EHS&L Document
SNM-1227 - Chapter 9
Environmental Protection

Nature of Changes

Document Number and Version: E10-08-009, 4.0

Figure 9-2 Groundwater Monitoring Wells

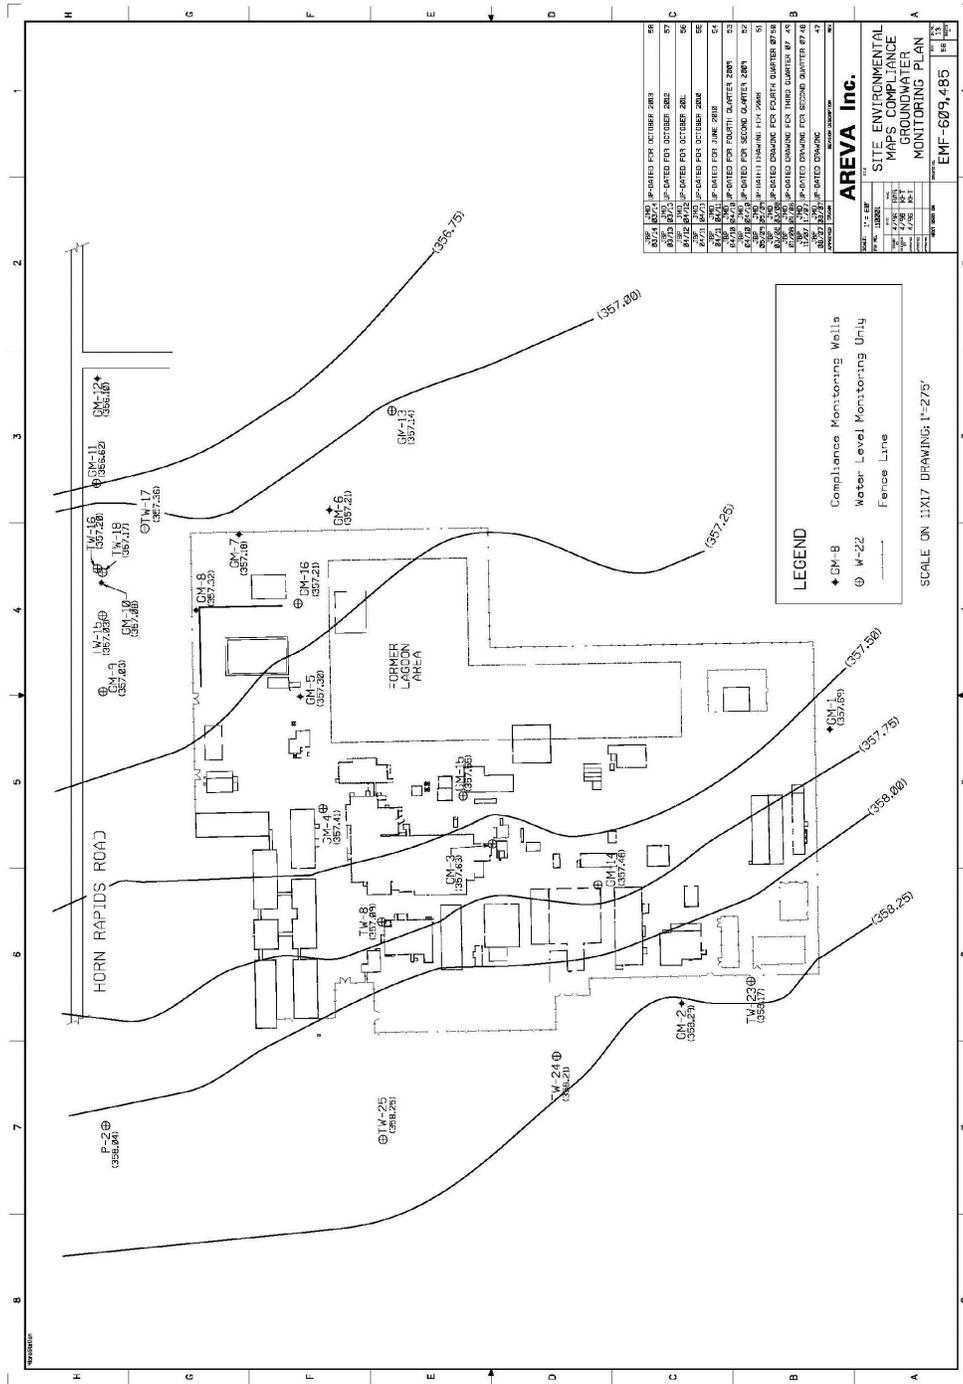
Item	Paragraph	Description	Justification
1.	9.4.2	Replaced "gross alpha beta" with "isotopic uranium and Tc-99"	Uranium and Tc-99 are the specific analytes of concern.
2.			
3.			
4.			
5.			
6.			
7.			
8.			
9.			
10.			
List Below any Documents, including Forms & Operator Aids which must be issued concurrently with this document revision:

Well Numbers	Frequency	Analysis
GM-1, GM-2, GM-5, GM-6, GM-7, GM-8, GM-10, GM-12	Semi-Annually	Isotopic Uranium, Tc-99, fluoride, nitrate, pH
